Filed safety notice to ripcords for treadmills built in 2014/2015

Users and operators of h/p/cosmos treadmills built in 2014/2015

All h/p/cosmos treadmills built in 2014 and 2015 equipped with a ripcord, clip and magnetic switch:

old

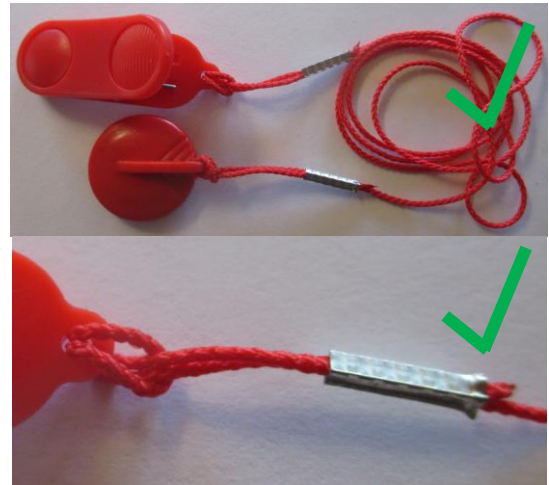
For the above-mentioned model series built in 2014 and 2015 it is possible, that in exceptional cases, the red cord between the magnet and the clip may not maintain the required tensile strength. This premature aging is probably caused by intense sunlight (UV radiation).

Since December 1, 2015 all affected treadmill models are equipped with a changed ripcord (article number cos101699-03), which has an increased protection against UV light and chemical influences (e.g. through aggressive cleaning agents or disinfectants).

From January 1, 2016 the red cord shall be replaced annually during the preventive maintenance and safety check service as recommended by the manufacturer.

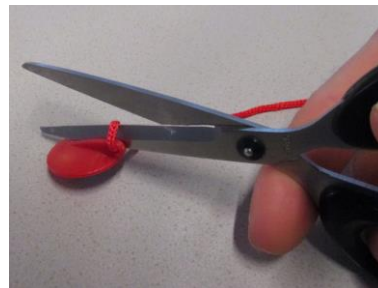
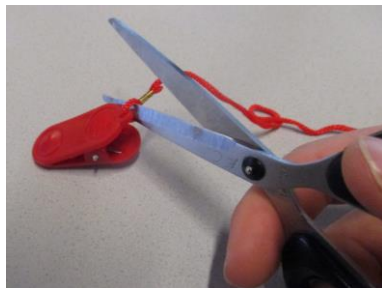
Immaculate condition: full red color	Material fatigue: discoloration from red to faded or white

1. Please make a visually and functional control of the ripcord including clip and magnetic switch.
2. The cord must have a full red color and must not show any cracks or damages.
3. Apply a tensile load of about 1 kg (10 N) at the clip. The cord must pull the magnet off the magnetic switch. The treadmill has to stop.
4. If the color fades this indicates premature aging due to external influences. The same applies for any cracks or other obvious damages of tissue.
